Village of Winnetka

Design Review Board/Sign Board of Appeals Regular Meeting

November 17, 2022 at 7:00 PM

At the October 3, 2022, DRB meeting, the Board considered the request to allow renovation of the existing commercial building **and** construction of site/streetscape improvements on the Subject Property. The materials and minutes from that meeting are included in **Attachment 2**. Given the property is in the C-1 Limited Retail Commercial District, the DRB is only a recommending body. At the October 3 meeting, and after receiving only one written comment from the public, the DRB discussed the proposed building and site/streetscape improvements. The Board recommended approval of the exterior building improvements as presented, by a vote of 7-0. However, the Board did not forward a recommendation regarding the site improvements as some members had concerns regarding the cohesiveness of the design. The Board asked staff to look at how the selected materials could be more cohesive, if there is a chance to add more green space, what could be done to use landscaping as a buffer to create a more intimate space, reconsider using the limestone seating boulders as the permanent seat

Figure 2 – Current Proposed Site Plan

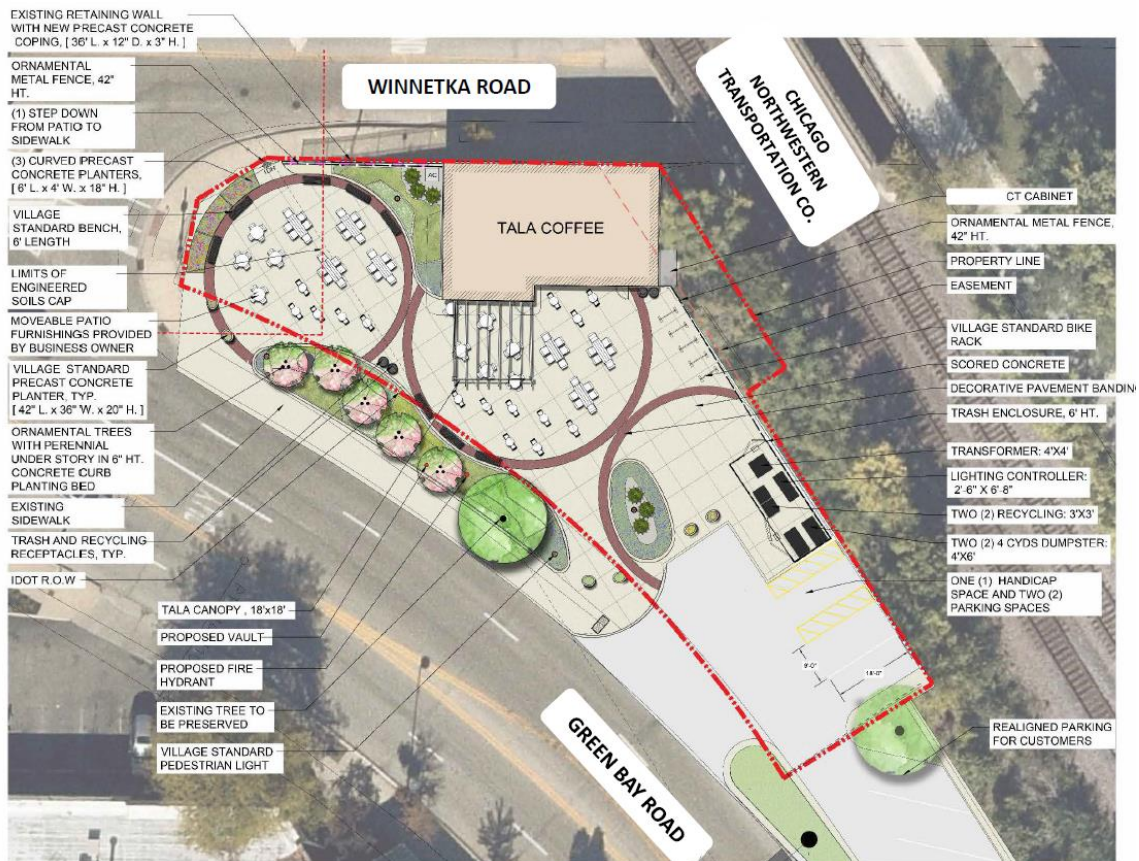
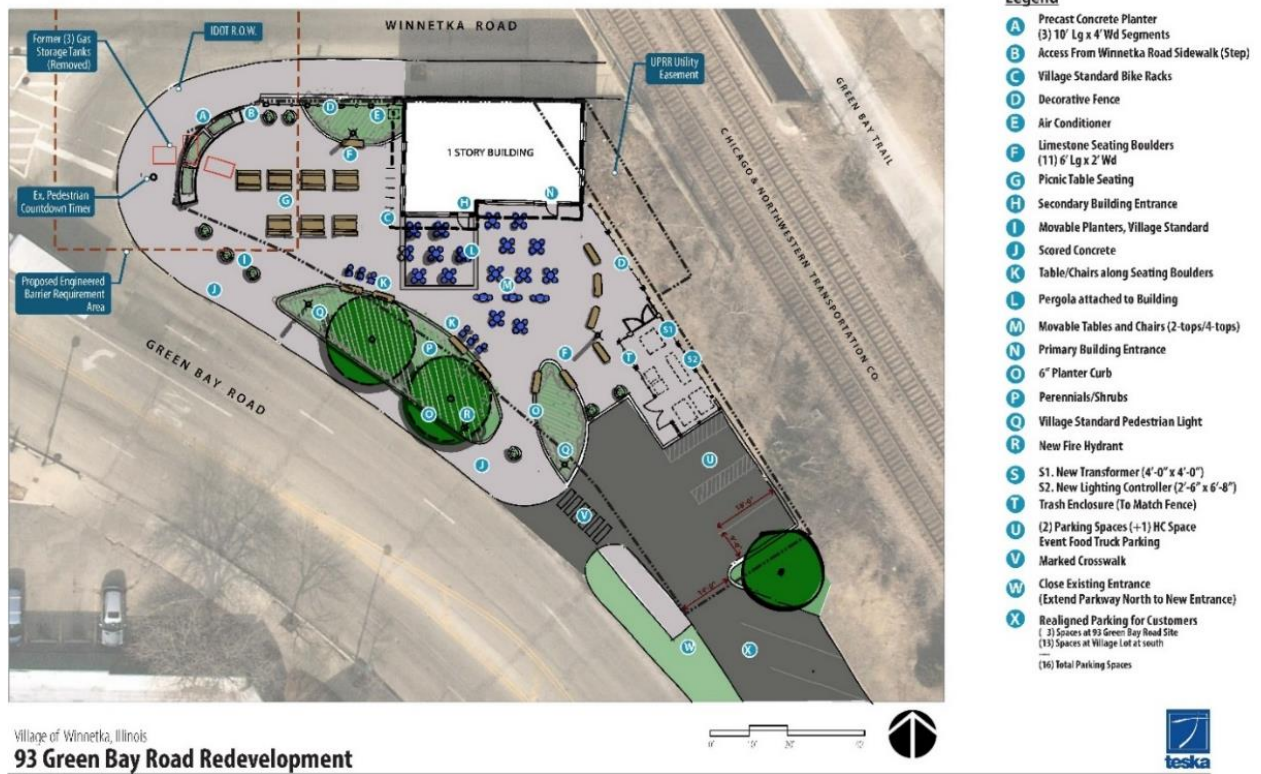
Following the meeting, staff worked with Jodi to develop a revised site improvement plan, which was then shared with the group. At the November 17 meeting, Jodi and staff will present in detail the revised site plan and the reasoning behind the changes. In summary, the following are issues raised by the Board and how they were addressed. The following page compares the current proposed site plan to the site plan presented at the October 3 DRB meeting. Attachment 1 includes all the information regarding the current proposed site/streetscape improvements.

2. **Provide additional green space.** The landscaping bed along Green Bay Road and the landscaping bed along the north property line have both been enlarged.

3. **Relocate bike racks to an area outside of the northwest plaza seating area.** The bike racks have been relocated to the east property line.
4. **Create a unified edge along the north and west property lines.** This has been accomplished by enlarging the landscape beds, providing landscaping details, the use of precast concrete planters and movable planters that incorporate the “parapet pattern” from the nearby railroad bridge, and refining the look of the retaining wall by adding a cap that is compatible with the precast concrete planters at the Green Bay and Winnetka Avenue corner.

5. **The limestone seating boulders appear as if they were just randomly placed on the site and seem out of place.** The limestone seating boulders have been replaced with backless metal benches that match the benches used in the downtown.

6. **Include a plan showing how pedestrians would access the Subject Property.** Such a plan is included with the materials in Attachment 1.

1
A2 PROPOSED FRONT ELEVATION
SCALE 1/4"= 1'-0"

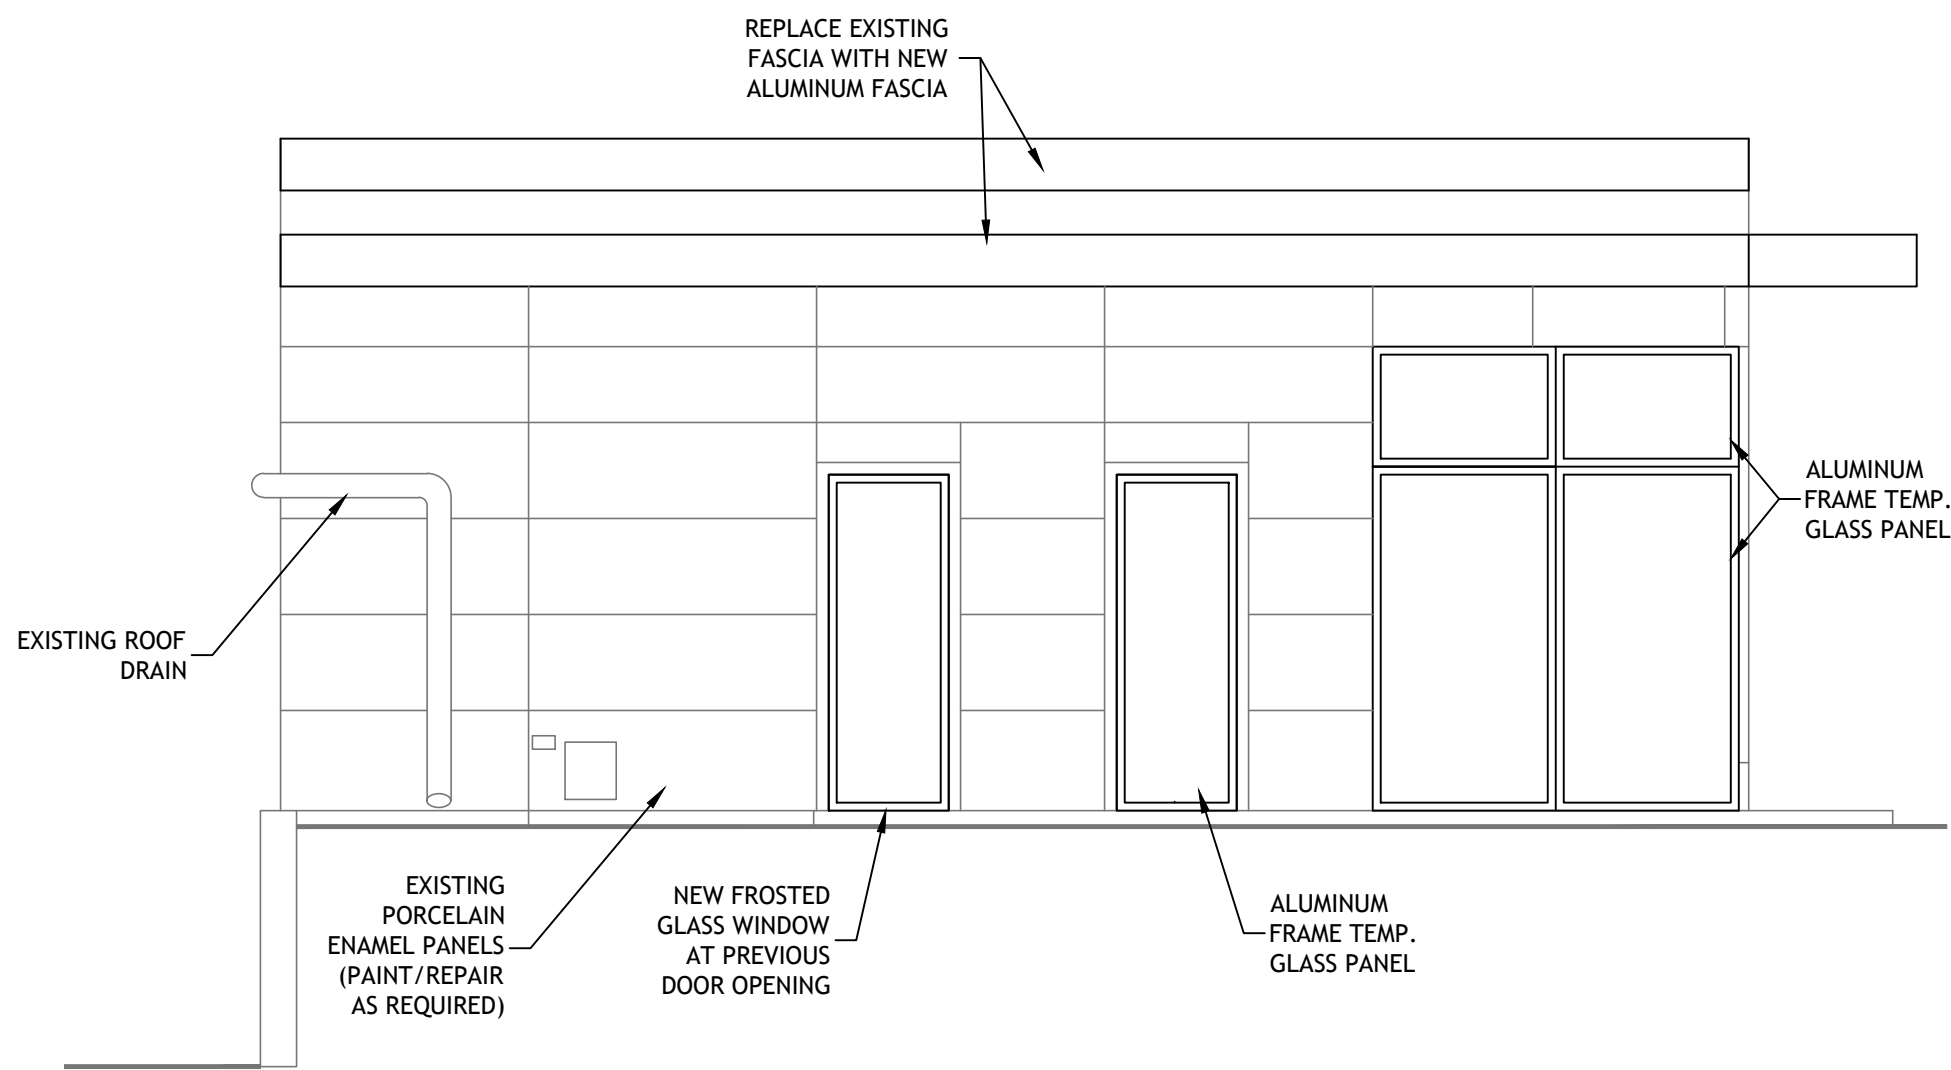
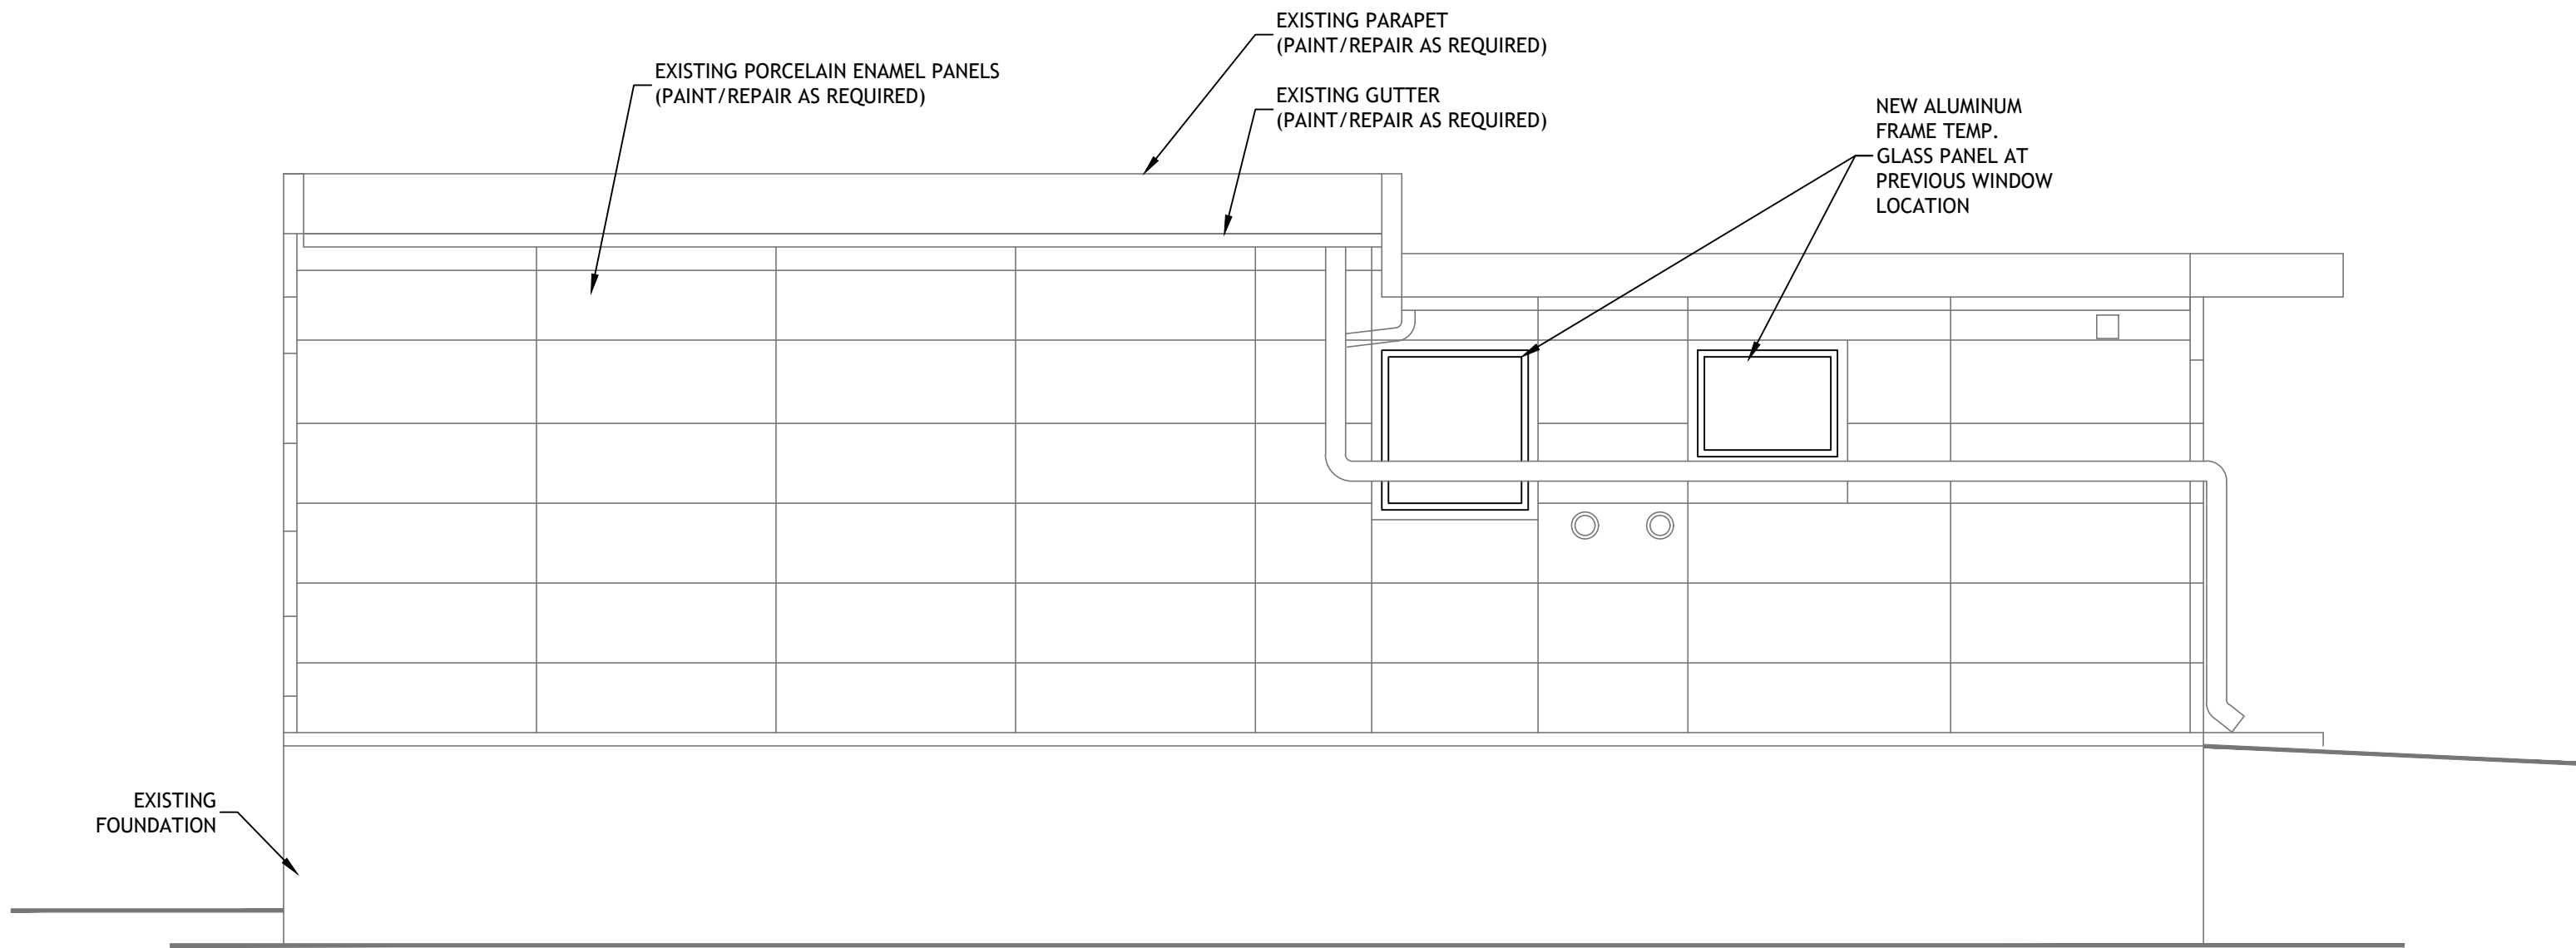
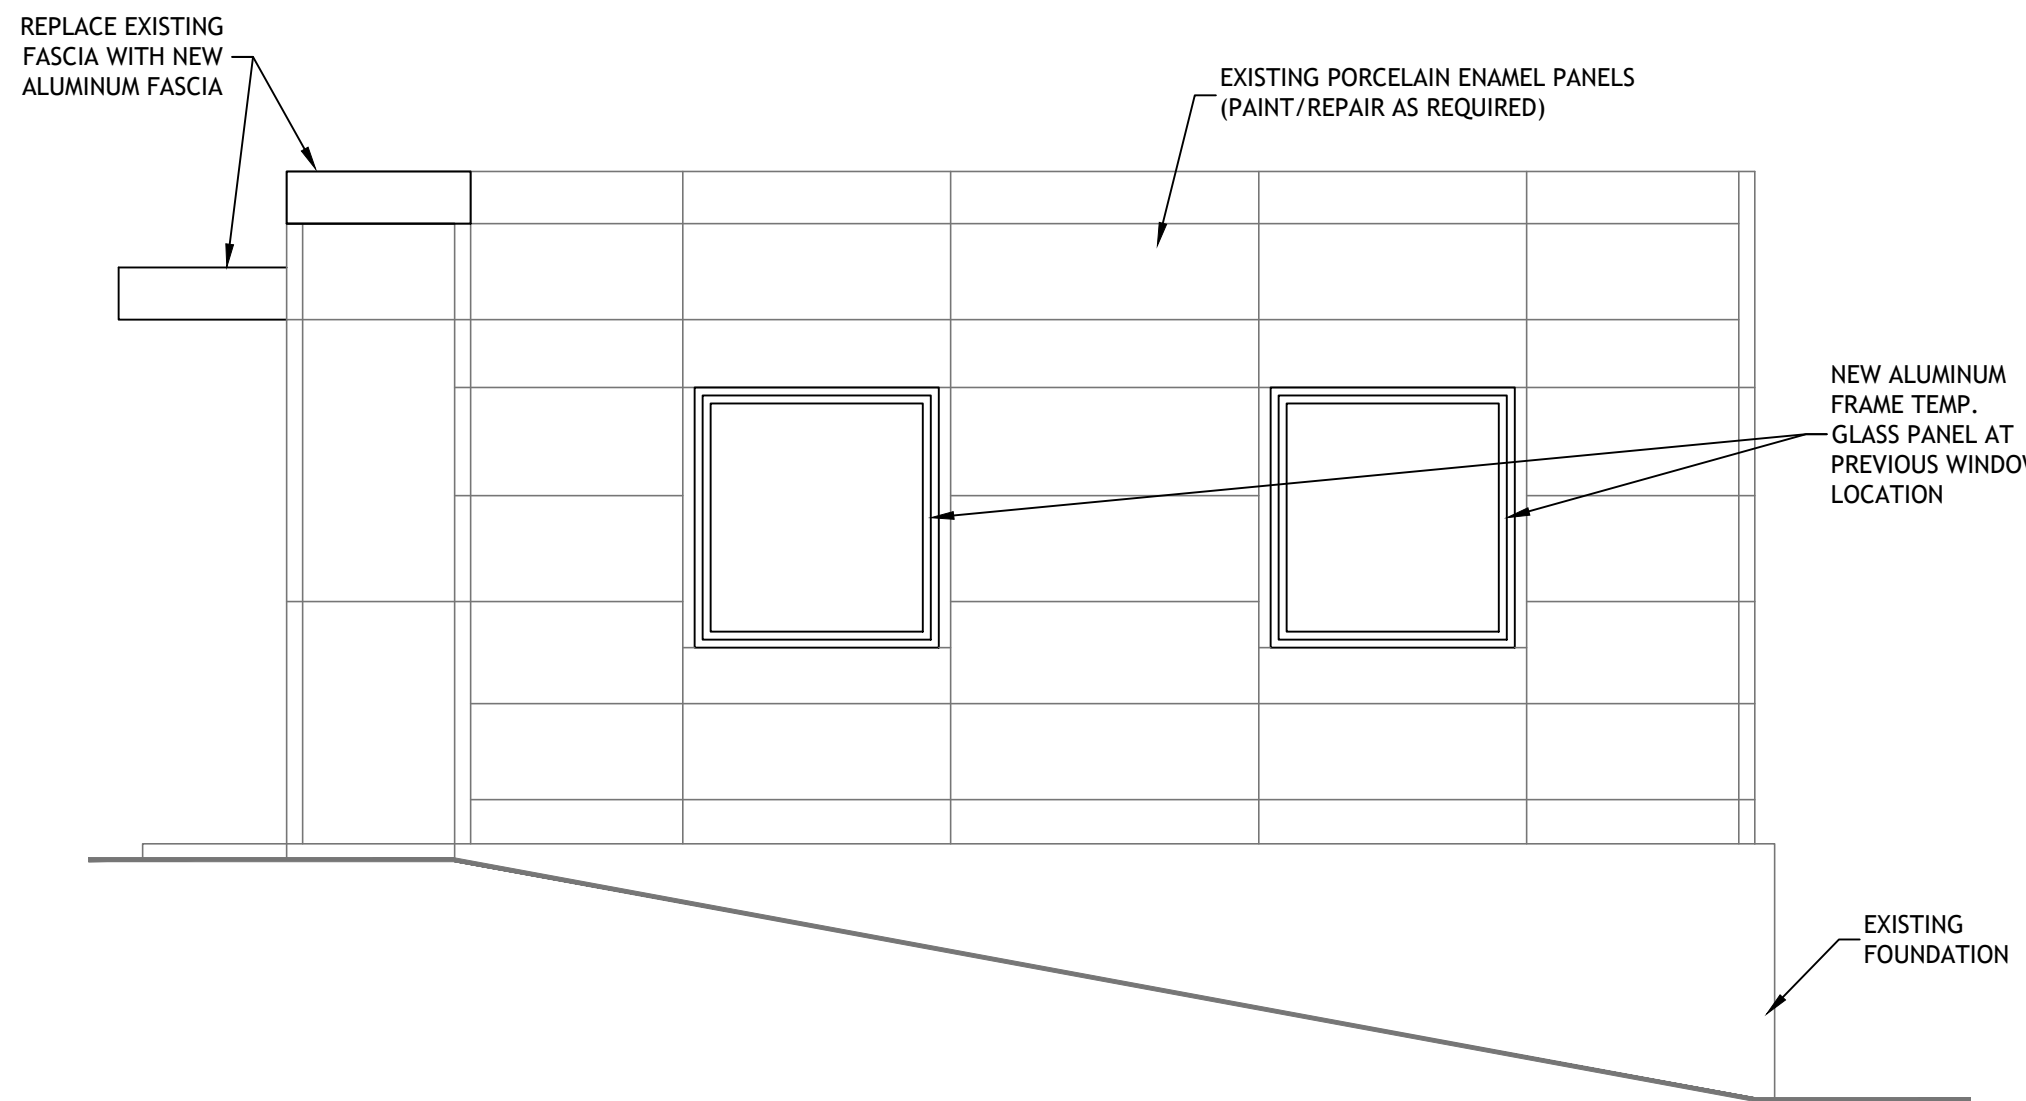
19 Chairman Albinson then referred to the west elevation illustration and questioned the rationale for the
20 windows on that elevation since they did not match the windows on the south elevation. Ms. Tong
21 confirmed that correction would be made to the rendering to contain two windowpanes and will match
22 the south elevation. Chairman Albinson asked if the interlocking louvers would keep rain out and the
23 applicants confirmed that is correct. Chairman Albinson asked if they considered locating the canopy on
24 the west elevation where there is more room. Ms. Tong explained the reasoning that alternative was not
25 chosen including mechanical elements in that area. Mr. Hickman added they cannot use that area due to
26 the inability to use underground footings.
27
